UNITED STATES PATENT AND TRADEMARK OFFICE

APPLICATION NO.	FILING DATE	FIRST NAMED INVENTOR	ATTORNEY DOCKET NO.	CONFIRMATION NO.
10/627,893	07/25/2003	Eric C. Hannah	42P12034D2	3477

Office Action Summary

DETAILED ACTION

REPLACEMENT SHEET

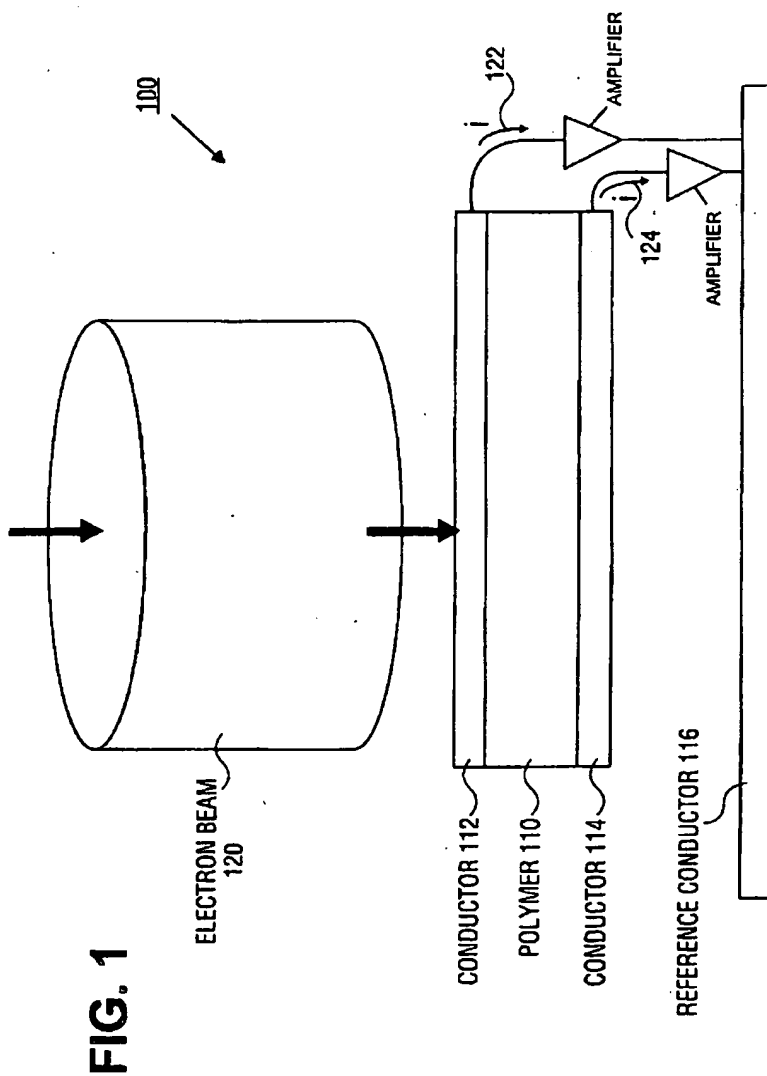
1. The replacement sheets of drawings were received on 9/21/06. These drawings are acceptable for the purpose of examination.
2. The drawings are objected to as failing to comply with 37 CFR 1.84(p)(5) because they include the following reference character(s) not mentioned in the description: ***amplifier in Fig. 1; interlayer in Fig. 2***. Corrected drawing sheets in compliance with 37 CFR 1.121(d), or amendment to the specification to add the reference character(s) in the description in compliance with 37 CFR 1.121(b) are required in reply to the Office action to avoid abandonment of the application. Any amended replacement drawing sheet should include all of the figures appearing on the immediate prior version of the sheet, even if only one figure is being amended. Each drawing sheet submitted after the filing date of an application must be labeled in the top margin as either "Replacement Sheet" or "New Sheet" pursuant to 37 CFR 1.121(d). If the changes are not accepted by the examiner, the applicant will be notified and informed of any required corrective action in the next Office action. The objection to the drawings will not be held in abeyance.

3. The drawings are objected to under 37 CFR 1.83(a). The drawings must show every feature of the invention specified in the claims. Therefore, ***the transparent layer as recited in claims 28 and 44*** must be shown or the feature(s) canceled from the claim(s). No new matter should be entered.

Regarding Fig. 1 of the present invention, it is not clearly understood and how either one of the currents may be used to associate the state of the conductivity within the polymer 110 with the memory state of data stored in a bit when the polymer 110 is highly resistive, as described in paragraph [0016] because, as seen in Fig. 1 of the present invention, when the polymer 110 is highly conductive, the current 122 and the current 124 are both pouring down to the reference conductor 116; similarly, it is not

clearly understood how once the current has been steered, according to the state of the polymer 110, many embodiments of the present invention may be used to read the current, as described in paragraph [0017] because, first of all, the specification does not clearly describe which of the current 122 or 124 has been steered according to the state of the polymer 110, secondly, Figs. 2-4 of the present invention do not show any embodiment associated with the reference conductor 116 as shown in Fig. 1 of the present invention, and, thirdly, as a result, it is not clearly understood what the reference conductor 116, as shown in Fig. 1 of the present invention, is really used for.

b) Regarding the objection to the drawings under Rule 37 CFR 1.83(a), the amended Fig.1 now show the amplifier as recited in claims 19-20. However, the specification fails to describe the amplifier and the substantially transparent layer as recited in claims 28 and 44 is still not shown in the drawings of the present invention.

Corrected drawing sheets in compliance with 37 CFR 1.121(d) are required in reply to the Office action to avoid abandonment of the application. Any amended replacement drawing sheet should include all of the figures appearing on the immediate prior version of the sheet, even if only one figure is being amended. The figure or figure number of an amended drawing should not be labeled as "amended." If a drawing figure is to be canceled, the appropriate figure must be removed from the replacement sheet, and where necessary, the remaining figures must be renumbered and appropriate changes made to the brief description of the several views of the drawings for consistency. Additional replacement sheets may be necessary to show the renumbering of the remaining figures. Each drawing sheet submitted after the filing date of an application must be labeled in the top margin as either "Replacement Sheet" or "New Sheet" pursuant to 37 CFR 1.121(d). If the changes are not accepted by the examiner, the applicant will be notified and informed of any required corrective action in the next Office action. The objection to the drawings will not be held in abeyance.

Appropriate correction is required.
